*Title of Item:*   **OP Development / Concept Plan Review:** Application from Landucci Homes requesting approval of an OP development concept plan that would create forty-four (44) lots on 90.15 gross buildable acres. The development is currently be called “Legends of Lake Elmo.”

City of Lake Elmo Planning Department  
**OP Development / Concept Plan Review**

Re: Legends of Lake Elmo – OP Concept Plan Review

## CONCEPT LAYOUT SOUTH

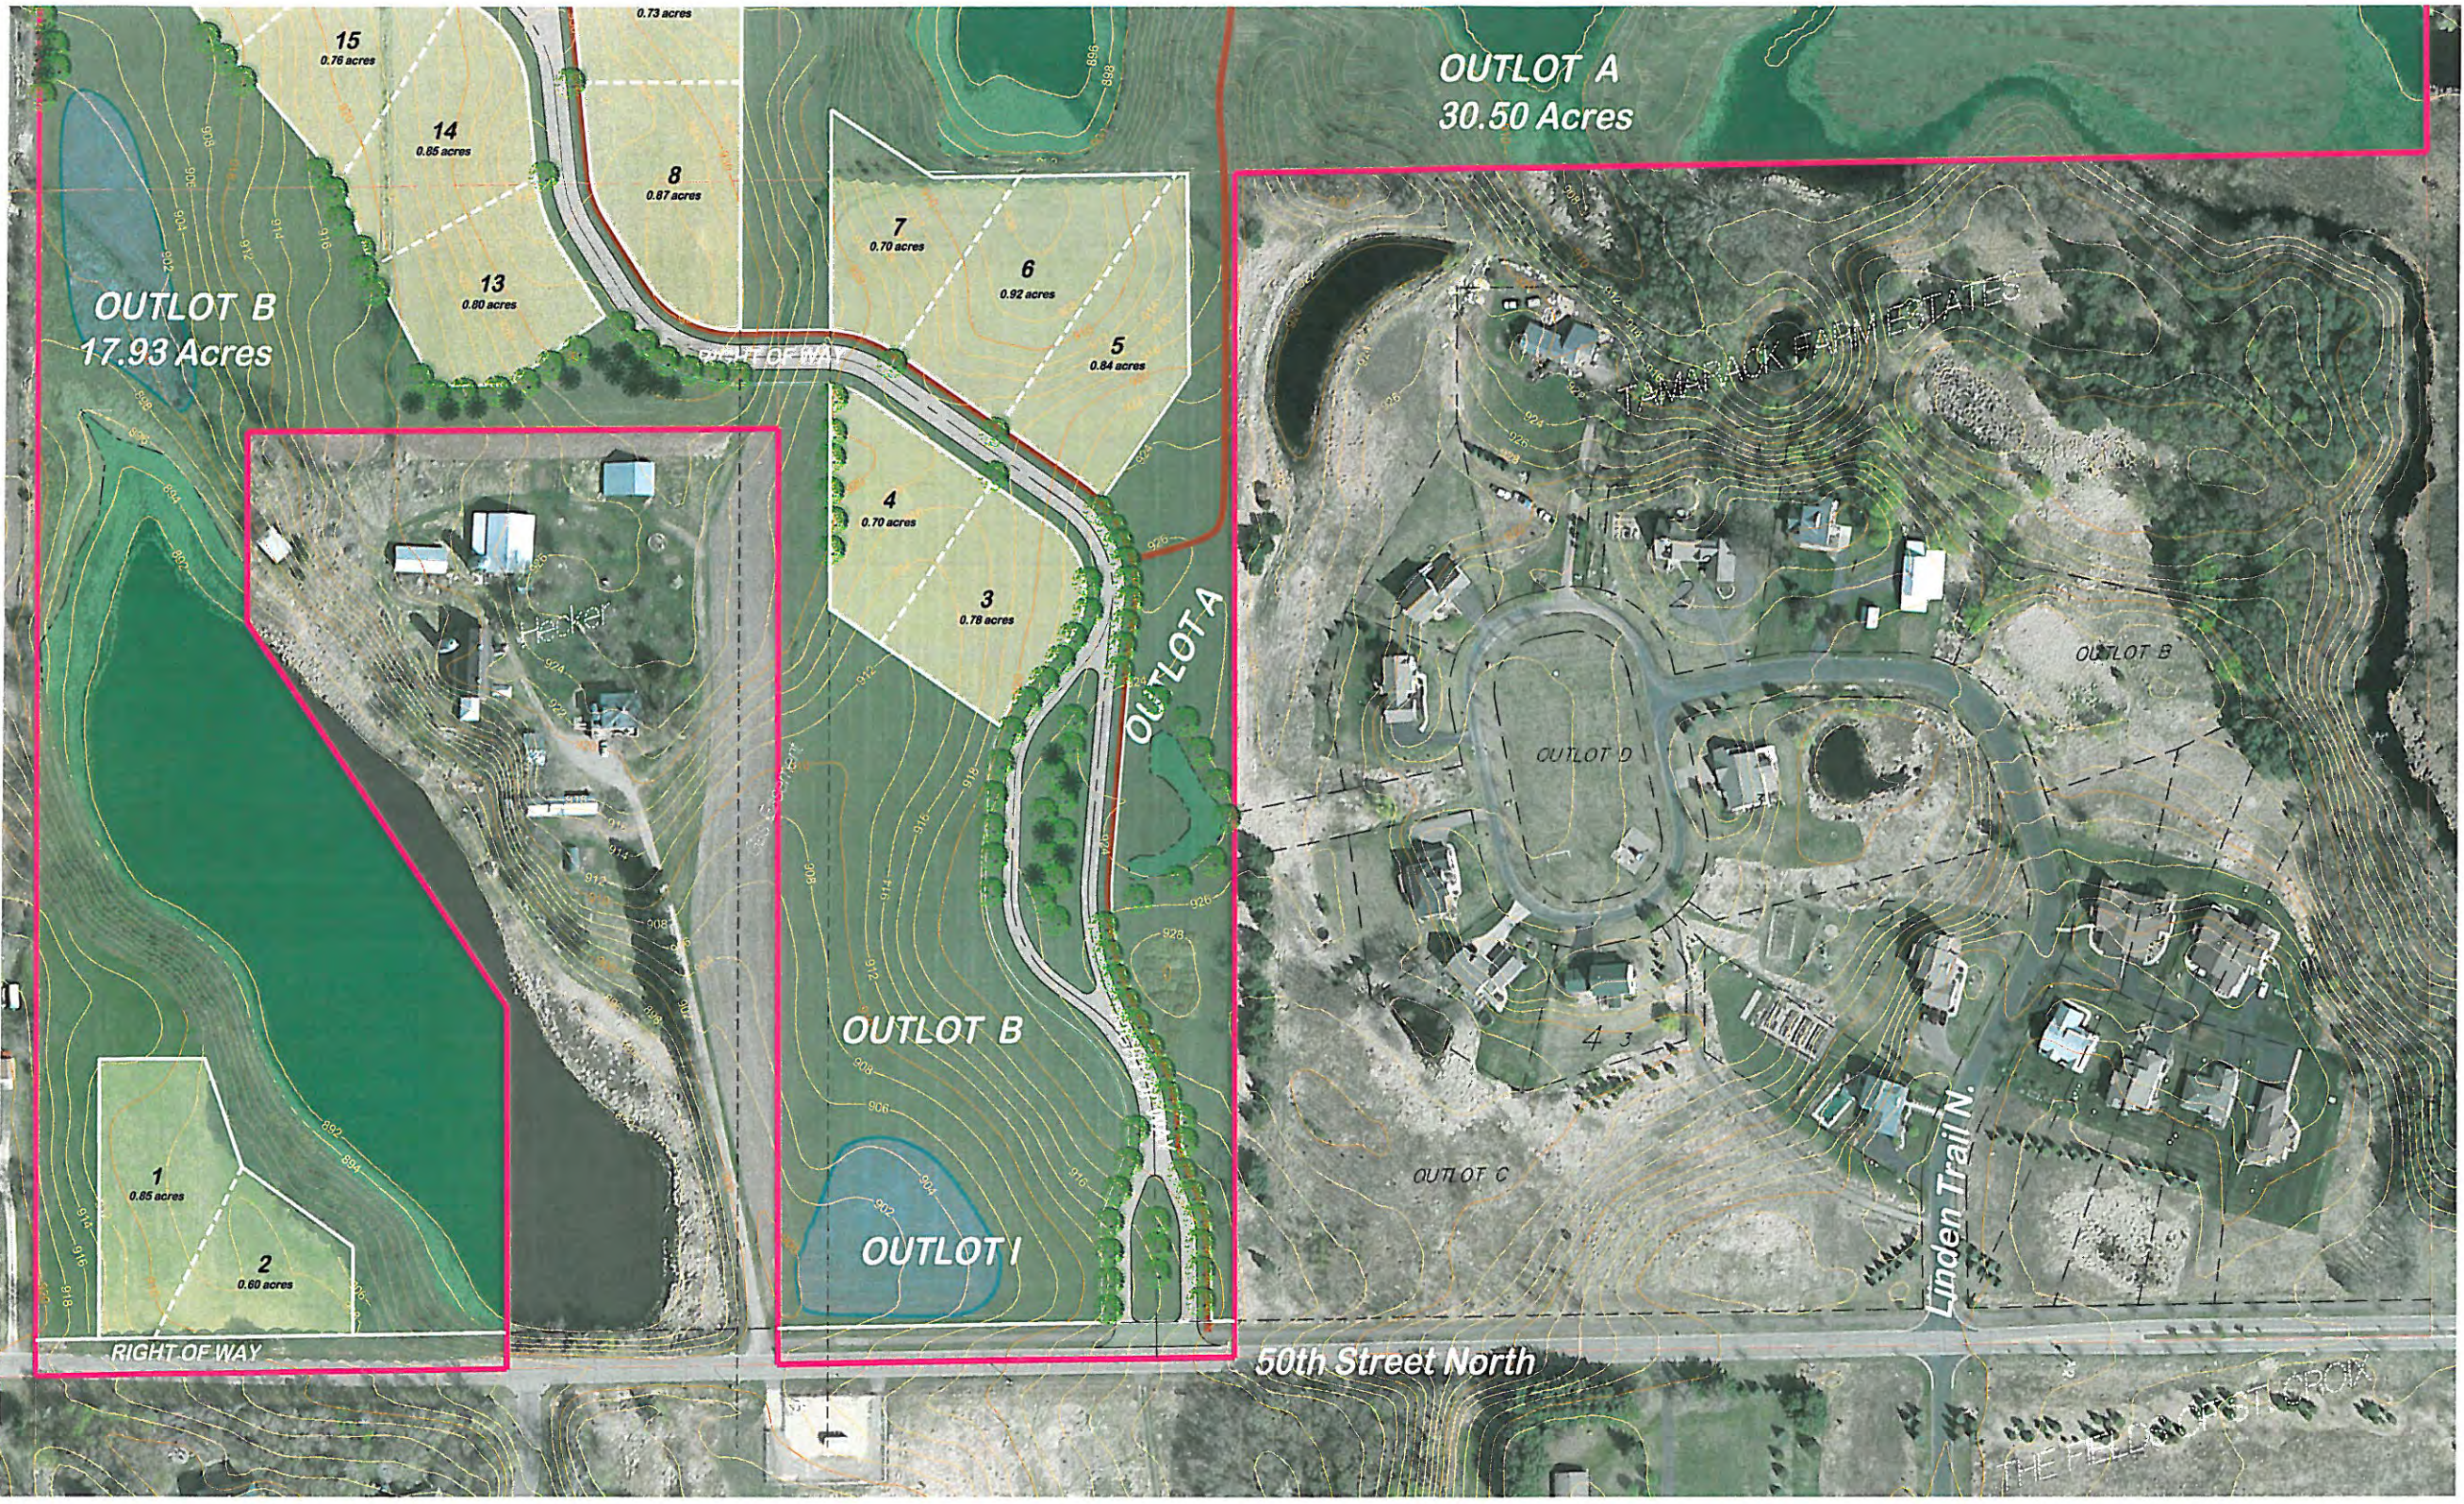
- The Concept Plan as submitted does not meet the City's Open Space Ordinance as follows:
  - The Open Space Ordinance requires a minimum of 1 acre lots when the Lots are served by individual septic systems. Only 1 of the 44 Lots is 1 acre or greater. Per the ordinance, single-family or multiple-family lots under 1 acre must be constructed with an individual septic tank and a communal drainfield.

- (cont.)
- The Open Space ordinance requires Lot design to be configured, as its highest priority, to utilize the most suitable soils for sub-surface septic disposal. The Concept Plans, as submitted to not provide soil survey and evaluation information and do not show the proposed primary and secondary septic system locations.

- The Concept Plan must be revised to be consistent with the Open Space Ordinance. Lot layouts must be revised to meet the 1 acre ordinance requirement and the primary and secondary septic system sites must be shown for each lot. Septic system sites must be placed where soil investigations demonstrate suitable soils and demonstrate that sufficient land is available to support both a primary and secondary septic system site for each proposed Lot.

- It is unclear from the concept plan if the proposed ponding and infiltration is on Outlots that will be dedicated to the City. It is also unclear from the concept plan if all wetlands and required wetland buffers are located on Outlots. Future plan submittals must address this information and requirements.

- The plans must include the 100-year HWL for all adjacent wetlands and water bodies and must demonstrate that the 100-year HWL does not encroach onto any proposed Lot.
